VISTA GRANDE DRAINAGE BASIN IMPROVEMENT PROJECT EIR/EIS

Environmental Impact Report/
Environmental Impact Statement Addendum
State clearinghouse NO. 2013032001

Prepared for
City of Daly City
National Park Service

June 2025

Modified Project Components (Canal)

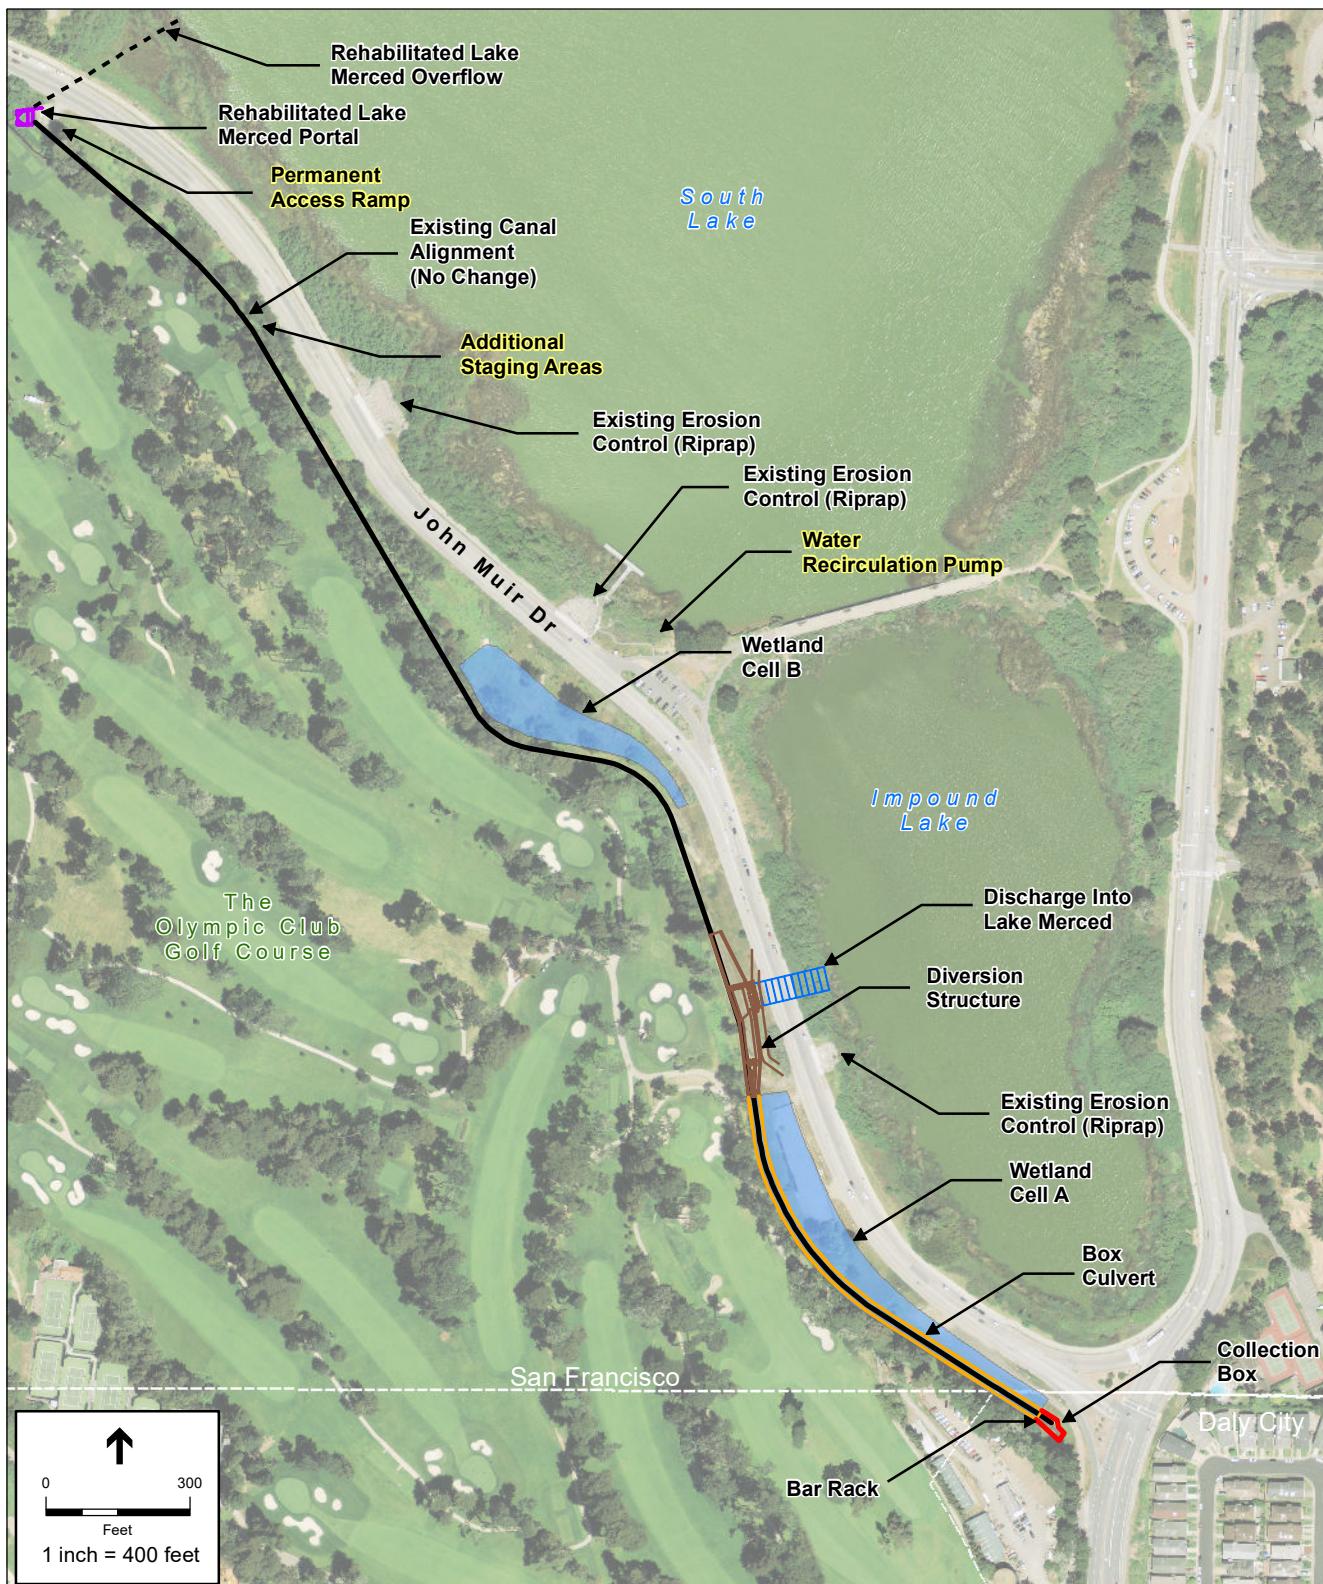
Under the Modified Project, sites along the Canal that were part of the overall Project footprint but were not likely to be disturbed would be used as a staging area for work on the Canal. The Modified Project would add staging areas adjacent to the Canal between the rehabilitated Lake Merced Portal and Wetland Cell B, with a footprint of 1.24 acres (see **Figure 2-1**). Additionally, a permanent access ramp would be installed to access the areas adjacent to the Canal from the rehabilitated Lake Merced Portal, which would provide access for maintenance and service activities.

The additional staging areas may require the installation of temporary chain-link fencing around the perimeter to serve as a buffer and screen from public views; however, the proposed staging areas do not provide public access. The proposed staging areas would be restored to pre-Project conditions after completion of construction activities.

Furthermore, the Modified Project would include the operation of a water recirculation pump, which would be permanently installed along the bank of Lake Merced (see Figure 2-1). As discussed in the EIR/EIS, the maximum sound level that can be expected to be generated by the water recirculation pump would be 84 dBA at a distance of 3 feet. The pump would be enclosed in an underground concrete structure to attenuate the noise generated by the pump. As discussed previously, the water recirculation pump would be located approximately 1,500 feet from the nearest sensitive receptor. Assuming a 10 dB attenuation from the concrete pump enclosure, the maximum combined noise level from the water recirculation pump would reach approximately 20 dBA at the nearest residential property boundary and therefore would have a less-than-significant impact.

Figure 2-4b
Modified Fort Funston Work Area

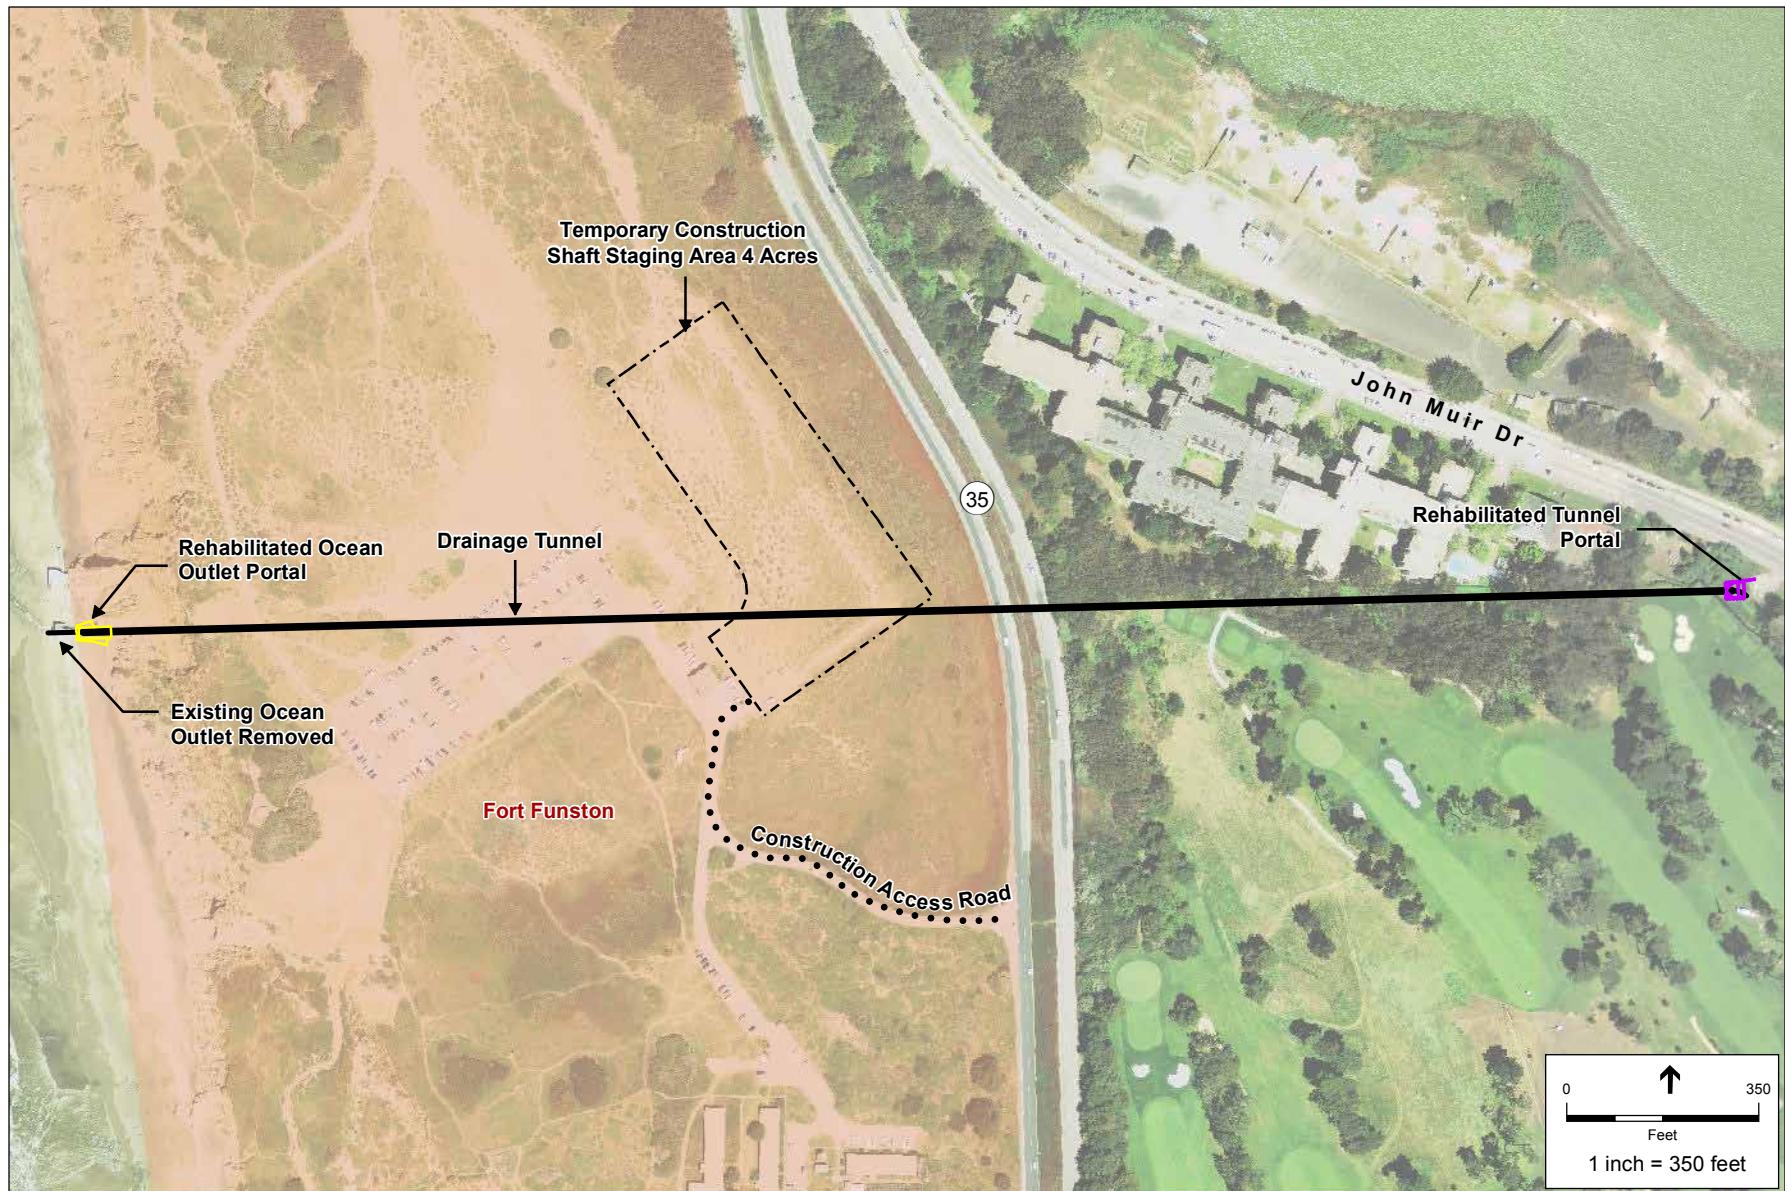
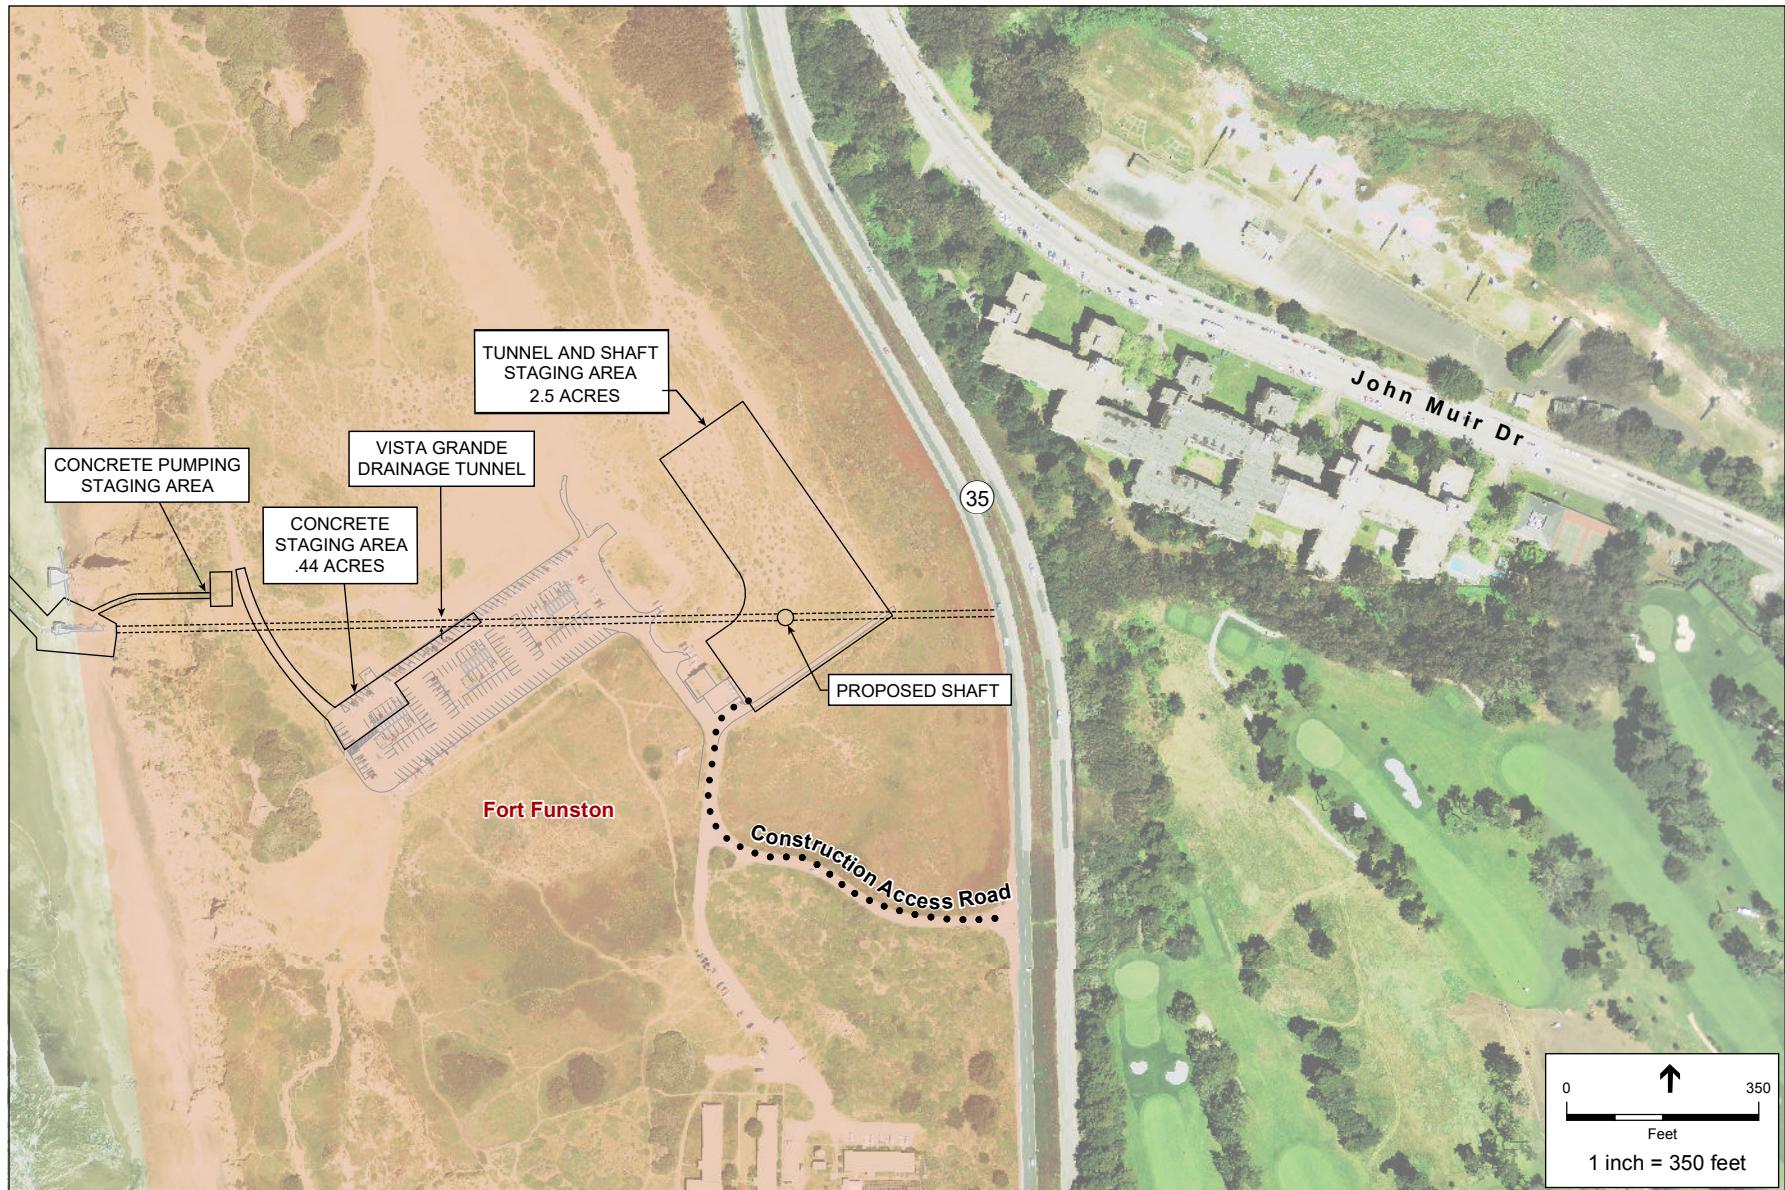
After certification of the EIR/EIS, modifications were made to the Project design. Under the Modified Project, the Fort Funston work area would be reduced to 2.5 acres, 1.5 acres smaller than originally estimated (see **Figure 2-4b**). The proposed modifications also include a new temporary work area located within the Fort Funston parking lot, 400 feet southwest of the Fort Funston tunnel and shaft work area.

The new work area would be 0.44 acre and would be located in the northwest corner of the Fort Funston parking lot. The work area would be used for concrete fabrication work, with access from Fort Funston Road off Skyline Boulevard. Concrete fabricated at this work area would then be moved to the concrete pump work area to the west, located along the top of the bluffs above the Ocean Outlet location on Funston Beach.

After certification of the EIR/EIS, Daly City determined that the use of a temporary PG&E service connection would not be feasible. Under the Modified Project, construction activities would be powered by seven additional generators ranging from 80 to 200 horsepower (hp). The generators would use diesel fuel and operate 24 hours a day, 5 days a week, until tunneling is

complete. The generators would be located within the Tunnel’s rehabilitated east portal work area (see Figure 2-1) and the modified Fort Funston tunnel and shaft work area (see Figure 2-4b).

Figure 2-5b
Modified Ocean Outlet Design

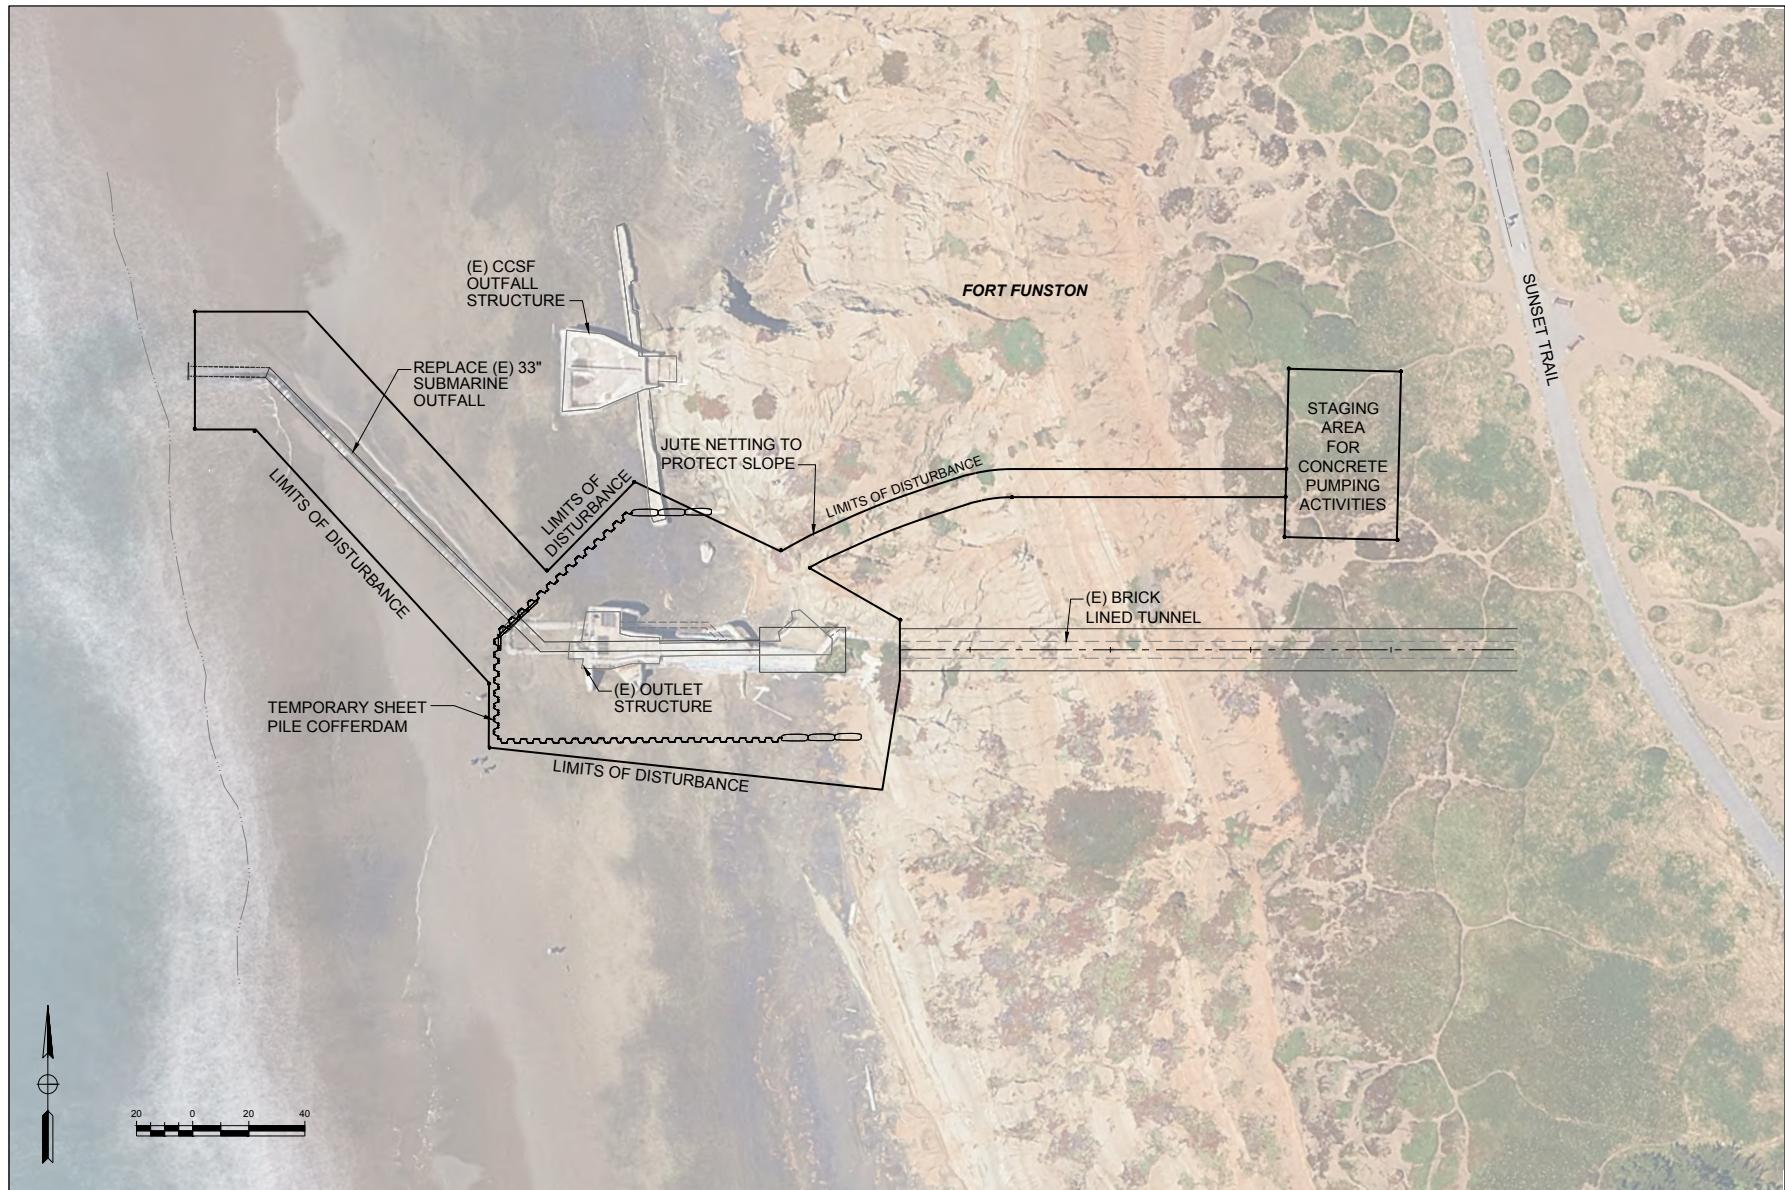
The design of the proposed Ocean Outlet structure, including the wing walls, considers the effects of sea level rise on both the operation of the outlet and the rate of cliff erosion. However, the Coastal Commission concluded that the two wing walls were not permittable as part of Project design. Thus, under the Modified Project, the wing walls would be removed from the final design of the Ocean Outlet (see **Figure 2-5b**).

There would also be other small changes to the design elements shown in the EIR/EIS, including additional supports for the anchor outfall pipe. Additionally, the work area for concrete pumping activities and the overall layout of the disturbed area for construction activities at the Ocean Outlet location would move just north of the disturbed area shown in Figure 2-5a (see Figure 2-5b for comparison). Jute netting would be laid on the cliff face to protect it from any disturbance from concrete pumping activities. After the completion of construction at the Ocean Outlet location, excavations would be backfilled and disturbed areas would be regraded with native soils to match existing profiles.

Under the Modified Project, the 70-foot and the 100-foot wing walls would be removed from the final design of the Ocean Outlet (see Figure 2-5b). There would also be other small changes to the design elements shown in the EIR/EIS, including additional supports to the anchor outfall pipe. The work area for concrete pumping activities and the overall layout of the disturbed area for construction activities at the Ocean Outlet location would move just north of the disturbed area shown in Figure 2-5a. However, beach access for recreationists would be maintained and temporary avoidance or restrictions would be in place only when vehicles and equipment are being transported along the beach and during the construction of the portion of the submarine outfall pipeline.
